## **DA15/0163 SECTION 4.55(1A) MODIFICATION – LOT 3989 LAKESIDE PARADE AND LOT 3991 JORDAN SPRINGS BOULEVARD, JORDAN SPRINGS**

This application has been prepared by Ethos Urban on behalf of Lendlease Communities pursuant to section 4.55(1A) of the *Environmental Planning and Assessment Act 1979* (EP&A Act) to modify Development Consent DA15/0163 relating to 3989 Lakeside Parade and 3991 Jordan Springs Boulevard, Jordan Springs.

The modifications relate to the removal of Lot 3991 and three buildings, and associated amendments to conditions of consent.

**Figure 1** Approved development layout showing the components to be retained (blue) and removed (red)  
 Source: Mosca Pserras Architects

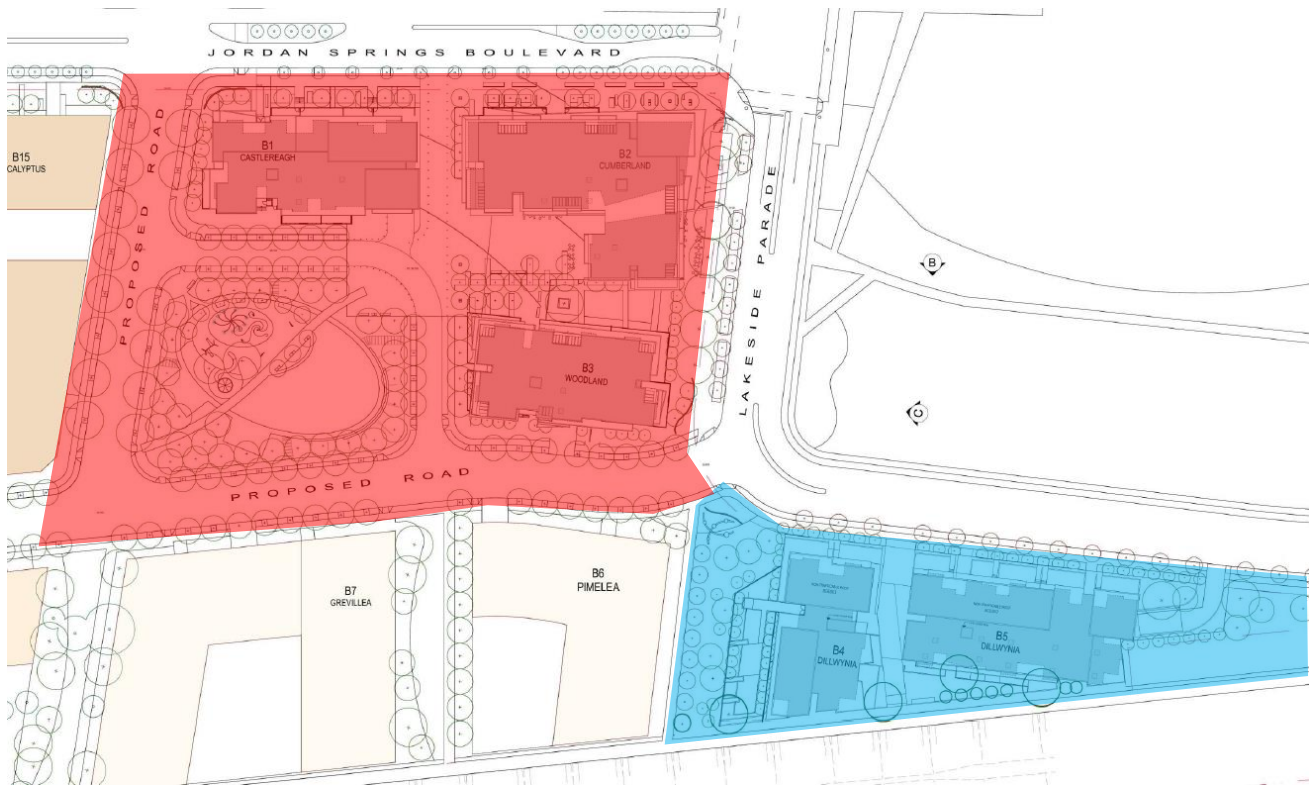
The following modifications are proposed to the approved development and relate to the removal of three buildings and Lot 3991:

- Removal of Lot 3991 from the site, resulting in a new site area of 5,025m<sup>2</sup> associated with Lot 3989;
- Removal of Buildings 1, 2 and 3 (Castlereagh, Cumberland and Woodland, the Central Park), situated on Lot 3991, resulting in the reduction of:
  - 137 residential apartments;
  - 626m<sup>2</sup> of non-residential floor space within Building 2; and
  - 263 car spaces.
- The removal of the 2,400m<sup>2</sup> Central Park;
- Removal of internal roads;
- Retention of three trees located on Lot 3991;
- Provision of waste storage facilities in Buildings 4 and 5; and
- Provision of landscaping including embellishment of publicly accessible space for Buildings 4 and 5.

**Figure 2** The components of the development proposed to be removed include Buildings 1,2 and 3 and the Central Park  
*Source: Mosca Pserras Architects*

**Figure 3** Buildings 4 and 5 are to be retained and the landscaping to be further embellished  
*Source: Mosca Pserras Architects*
